Tennessee Valley Authority, Post Office Box 2000, Decatur, Alabama 35609-2000

TVA-BFN-TS-416

**BROWNS FERRY NUCLEAR PLANT (BFN) - UNIT 3 - TECHNICAL SPECIFICATIONS
(TS) CHANGE 416 - REVISED SAFETY LIMIT MINIMUM CRITICAL POWER RATIO
(SLMCPR) (TAC NO. MB0436)**

PROPOSED TECHNICAL SPECIFICATIONS (TS) CHANGE TS-416 DESCRIPTION AND EVALUATION OF THE PROPOSED CHANGE

Figure 1 Reference Core Loading Pattern – Cycle 10

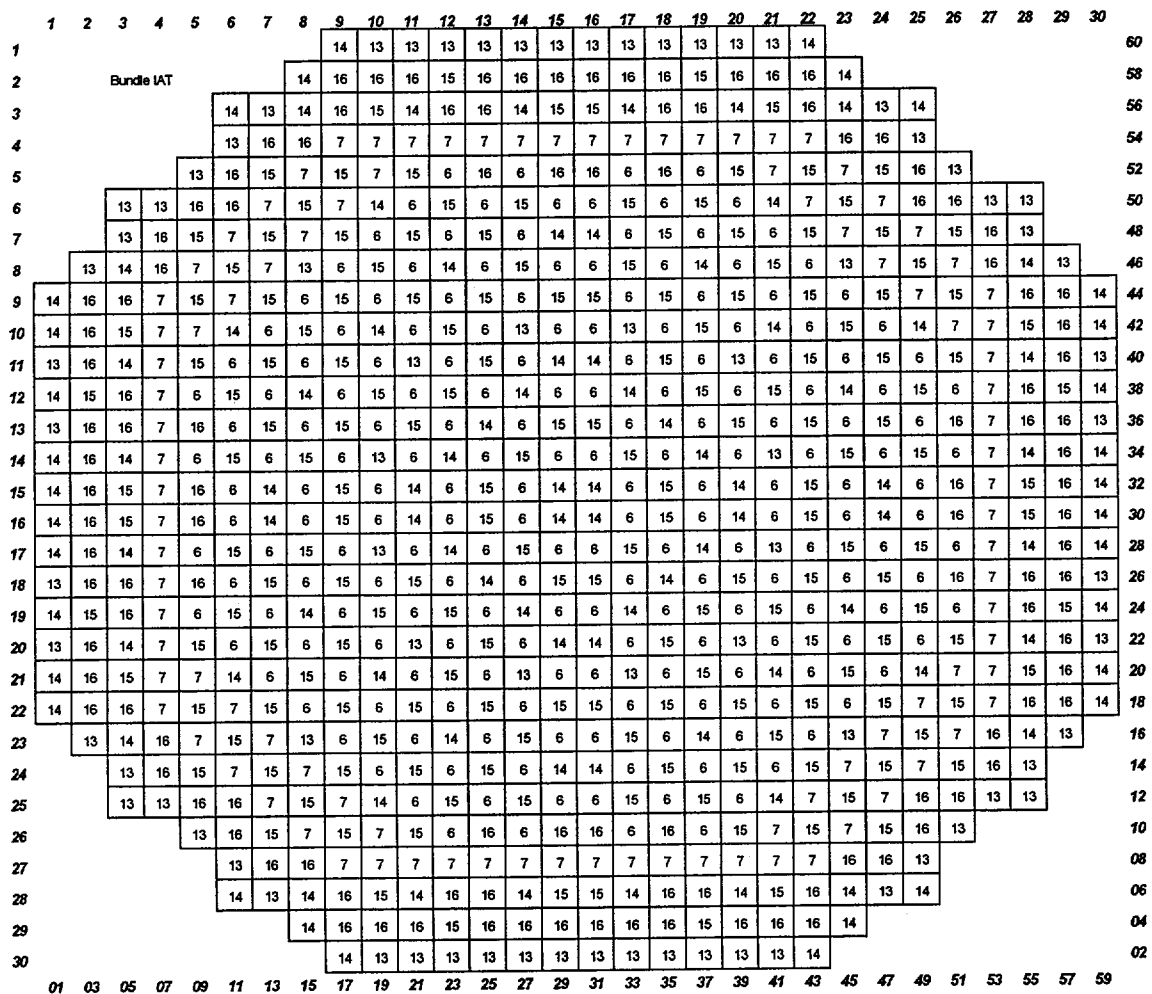
The core loading information for Browns Ferry Unit 3 Cycle 10 and 11 is provided in Figures 1 and 2, respectively. The impact of the fuel loading pattern differences on the calculated SLMCPR is correlated to the values of [[]] The power and non-power distribution uncertainties that are used in the analyses are indicated in Table 1.

Figure 2 Reference Core Loading Pattern – Cycle 11

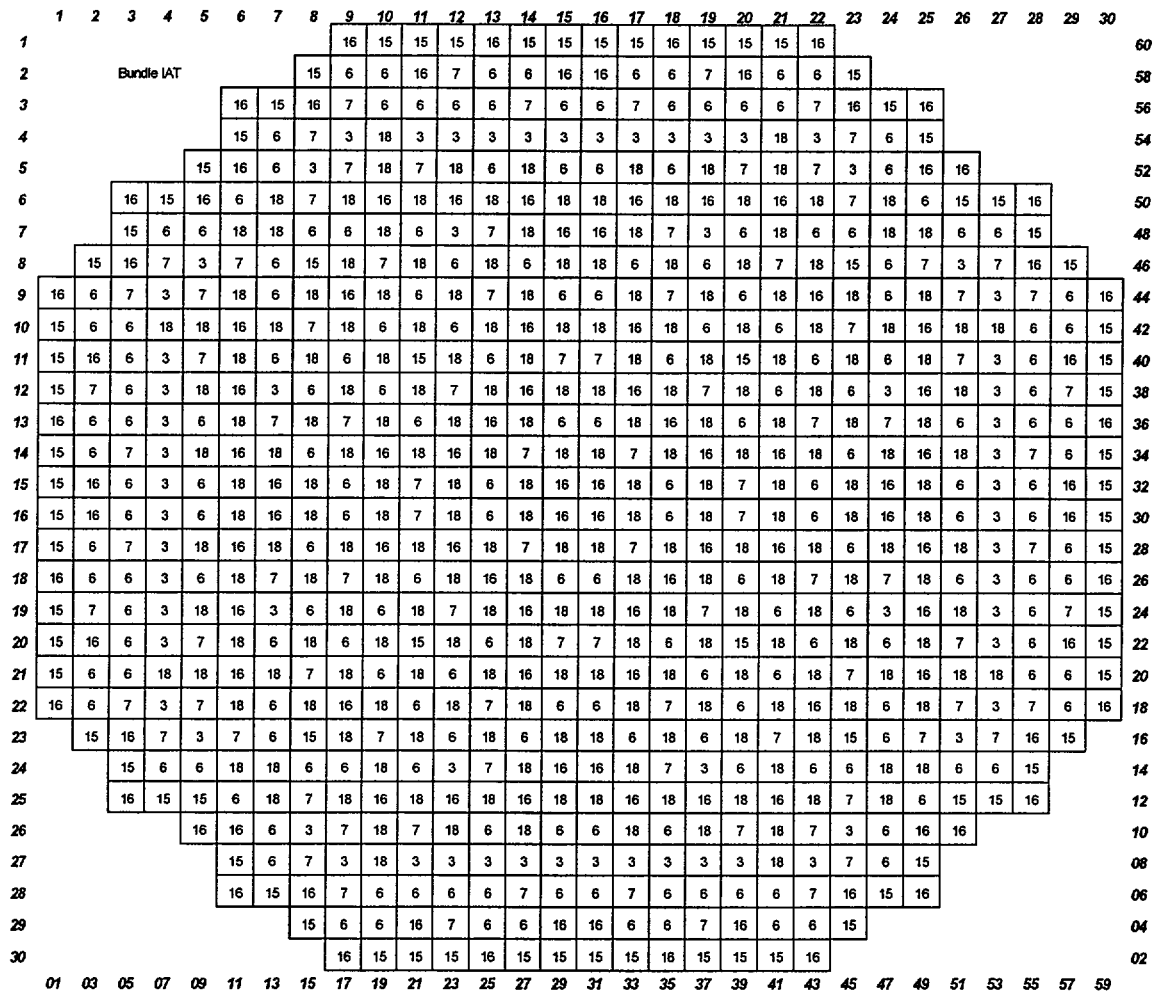
The uncontrolled bundle pin-by-pin power distributions were compared between the Browns Ferry Unit 3 Cycle 11 bundles and the Cycle 10 bundles. Pin-by-pin power distributions are characterized in terms of R-factors using the NRC approved methodology^[2]. For the Browns Ferry Unit 3 Cycle 11 limiting case analyzed at PHE, [[]] the Browns Ferry Unit 3 Cycle 11 bundles are flatter than the bundles used for the Cycle 10 SLMCPR analysis.
